RECEIVED
NOV 12 1997
HYDROLOGY SECTION

FUDDRUCKER'S

GRADING AND DRAINAGE PLAN

FUDDRUCKER'S
GRADING AND DRAINAGE PLAN

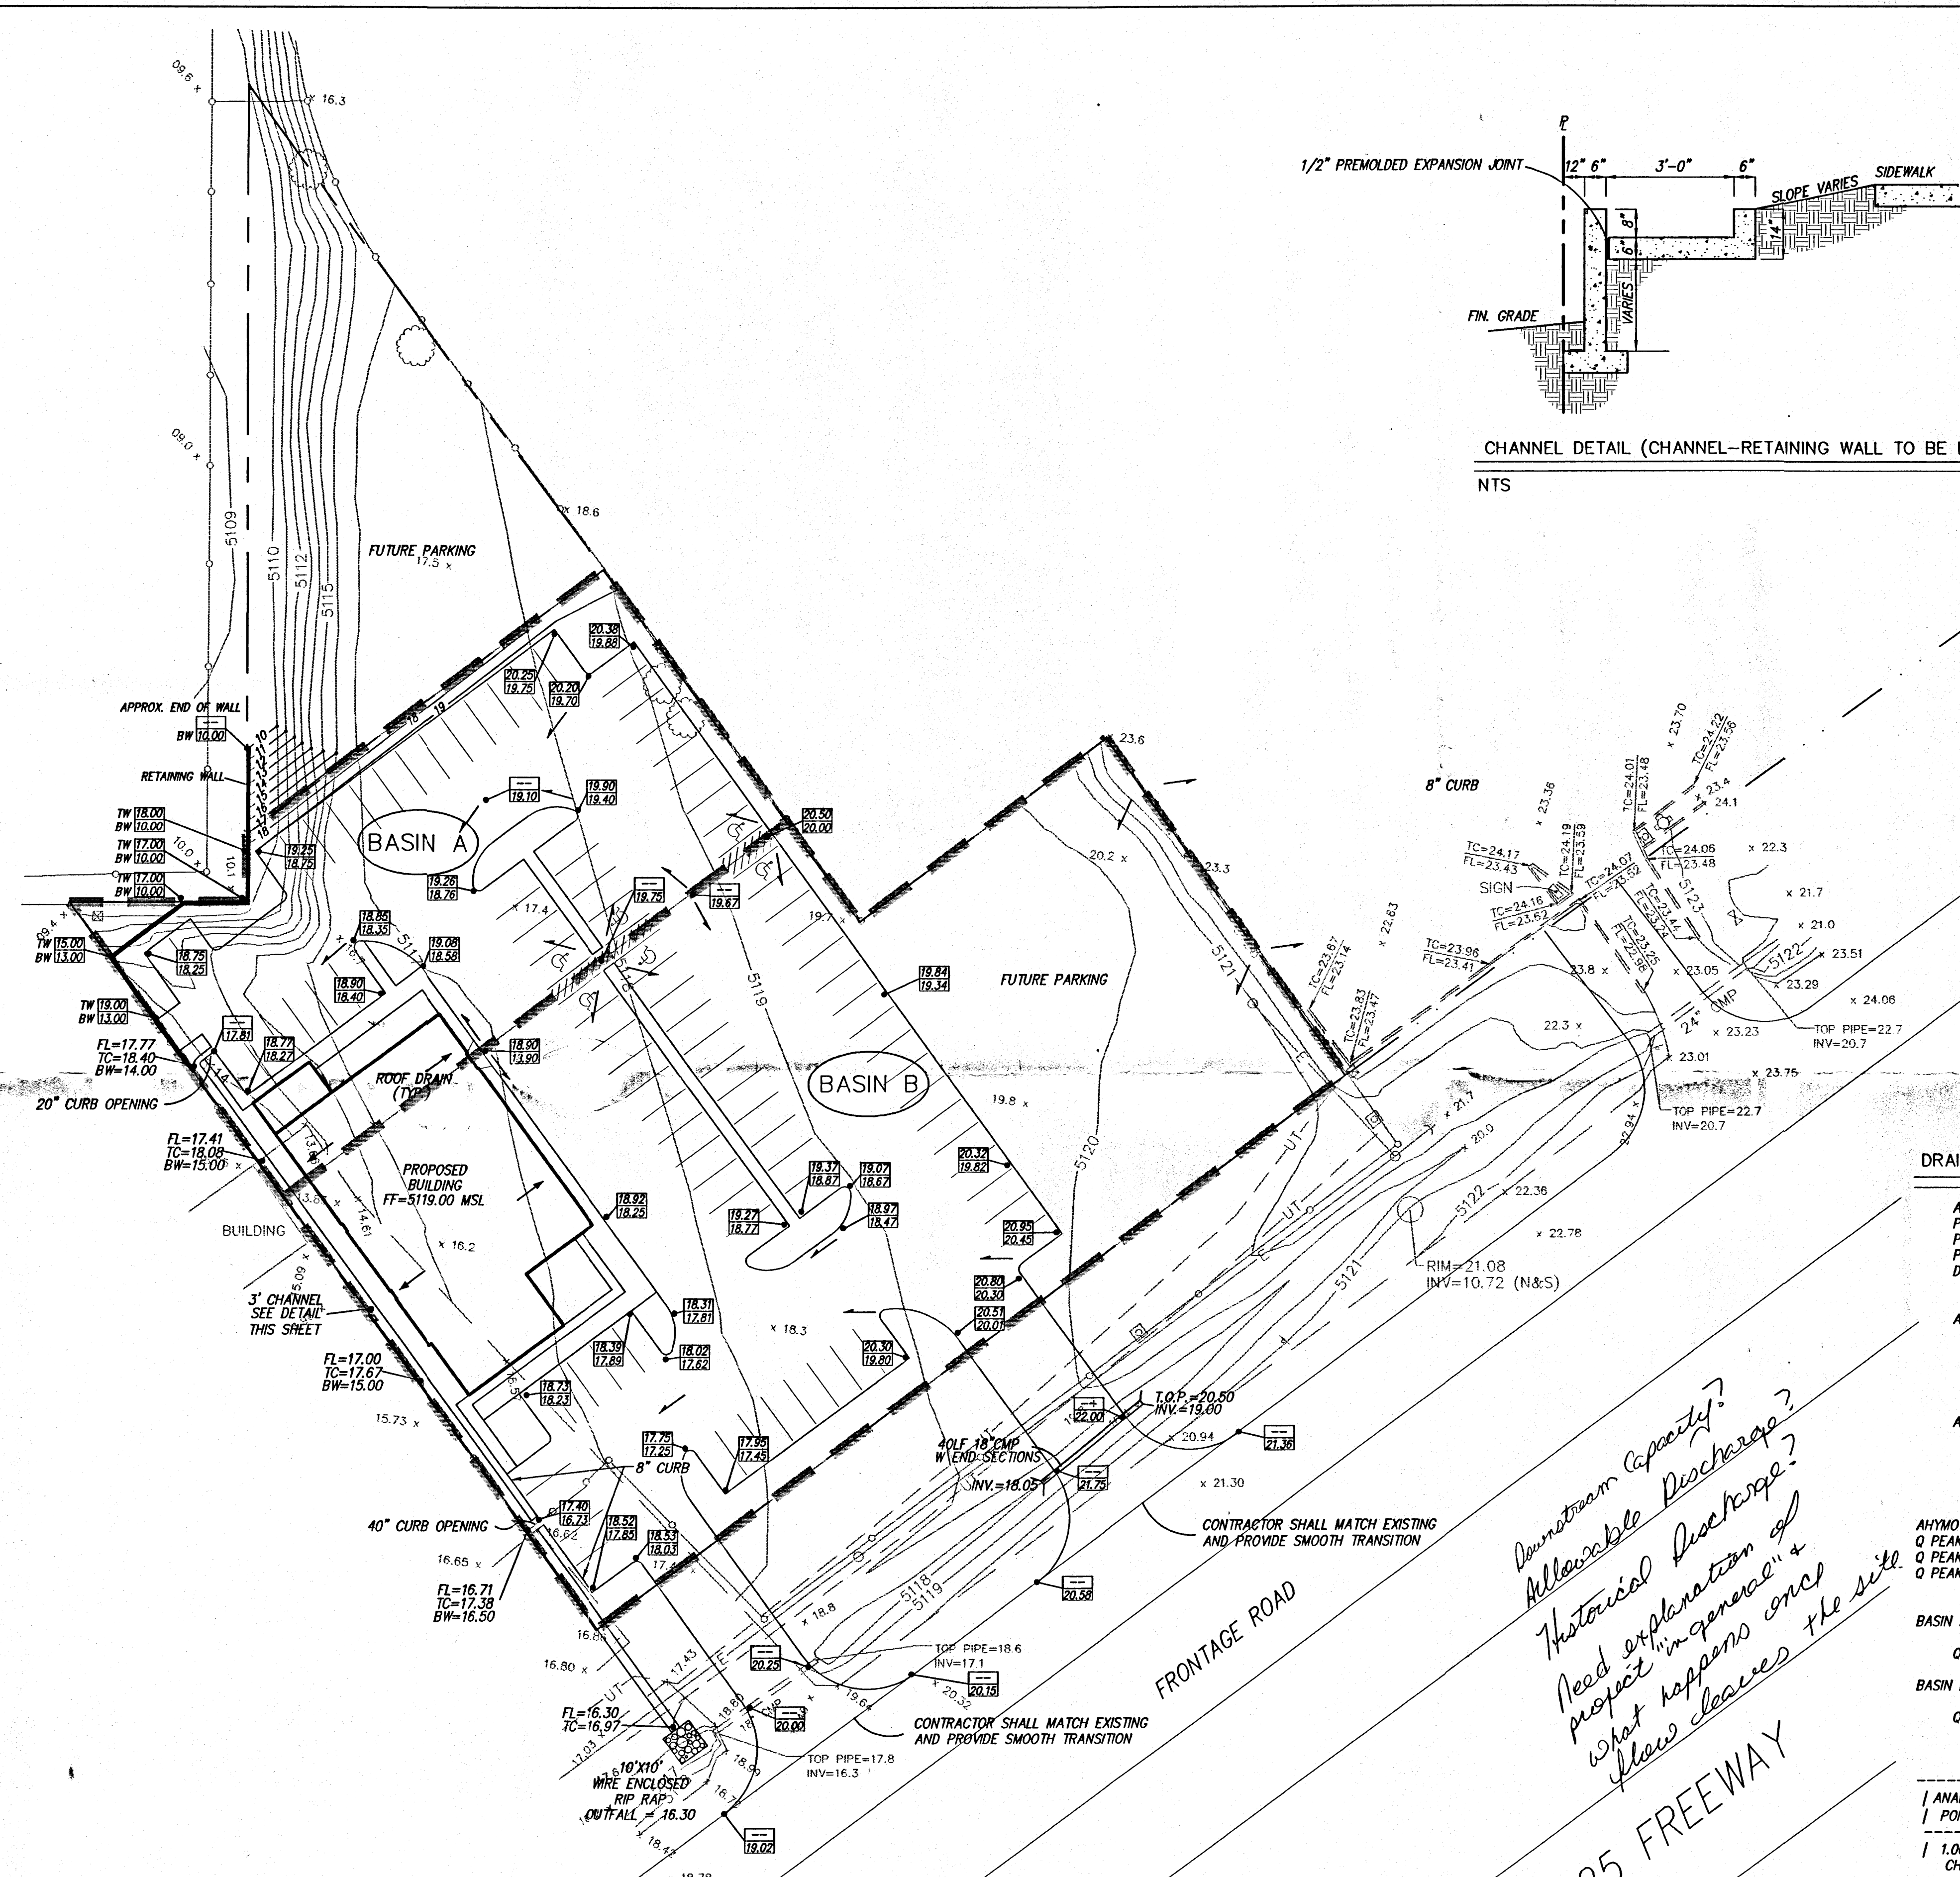
*Downstream Capacity?
Allowable Discharge?
Historical Discharge?
Need explanation of
project "in general" &
what happens once
flow leaves the site.*

FUDDRUCKER'S
GRADING AND DRAINAGE PLAN

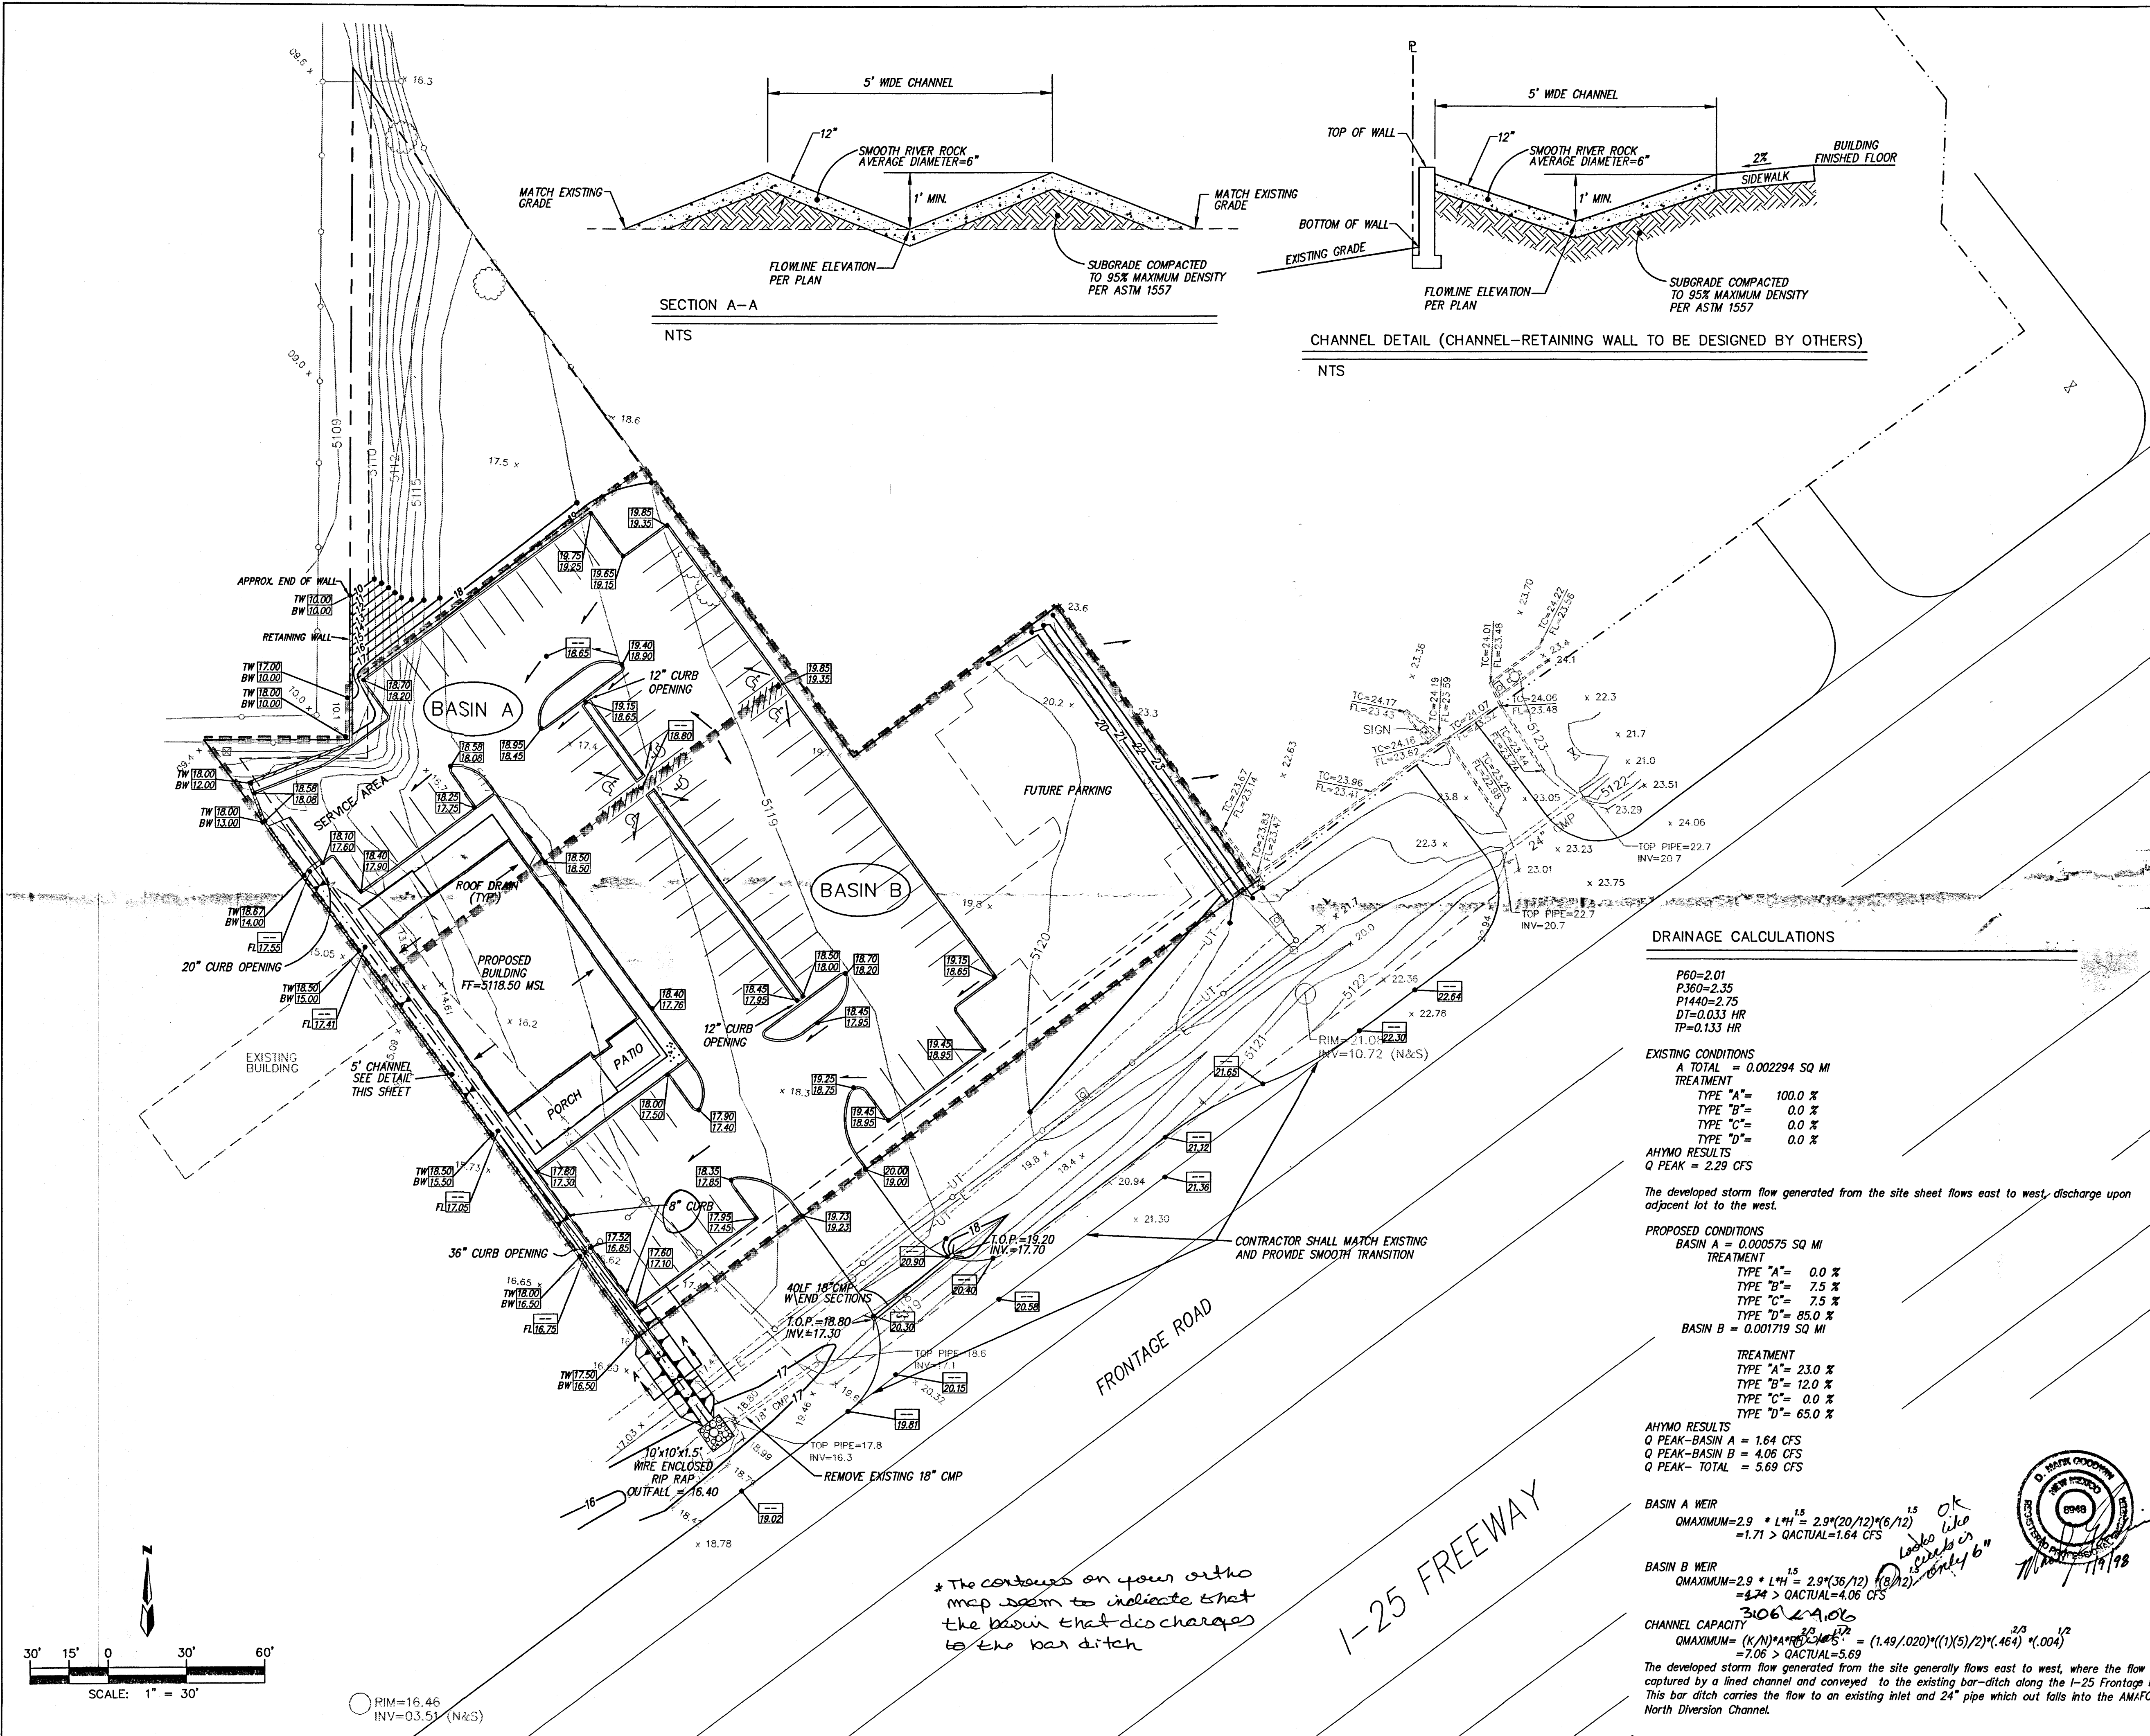
* The contours on your ortho map seem to indicate that the basin that discharges to the bar ditch
